CITY OF ALBUQUERQUE

RE: **Lot 10 Block 9 Volcano Cliffs Unit 18 SAD 228
6528 Papagayo Rd. NW
Grading and Drainage Plan
Revised Engineers Stamp Date 9/8/2021 (D10D003I10)**

SHEET TITLE:
**GRADING AND
 DRAINAGE PLAN**

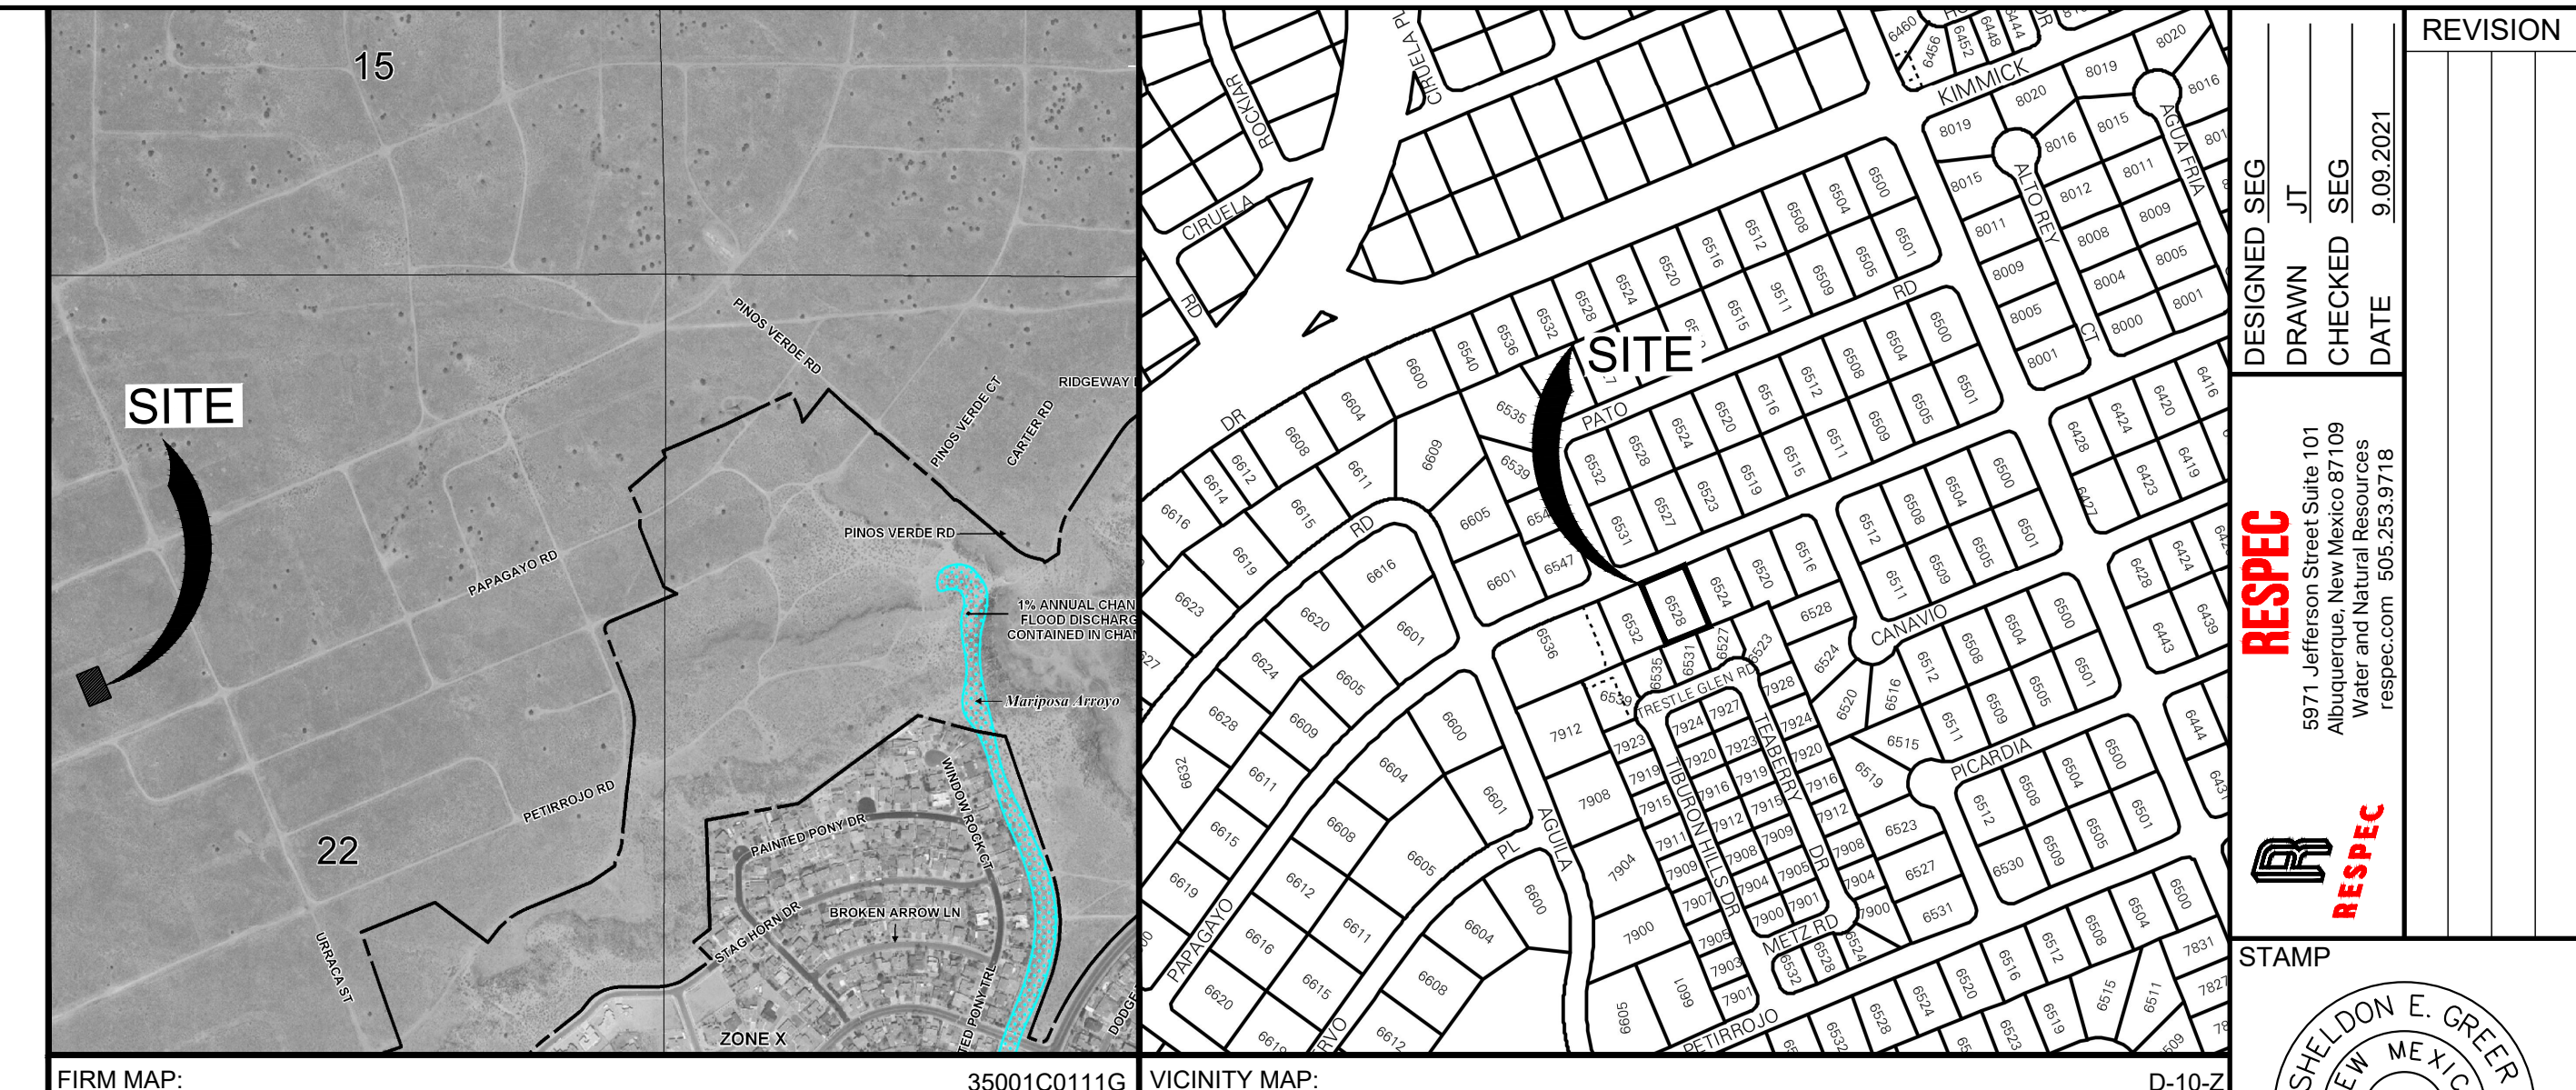
Based upon the information provided in your submittal received 9/8/2021, this revised plan is approved for Grading Permit.

Prior to Building permit approval a Pad Certification will be required, provided by the Engineer or a registered Land Surveyor. Notify the Owner/Contractor not to use dirt as a ramp to climb the curb. They may use crusher fines or lumber for this process. If dirt is used this will stop the approval process until street is cleaned to my satisfaction.

Reiterate to the Owner/Contractor that a separate permit for a garden/retaining wall must be obtained with the approved G&D plan and Pad Certification. **Also, if a swimming pool is to be placed the grading and drainage plan will change and will need to be resubmitted.**

Prior to Certificate of Occupancy release, Engineer Certification per the DPM checklist will be required.
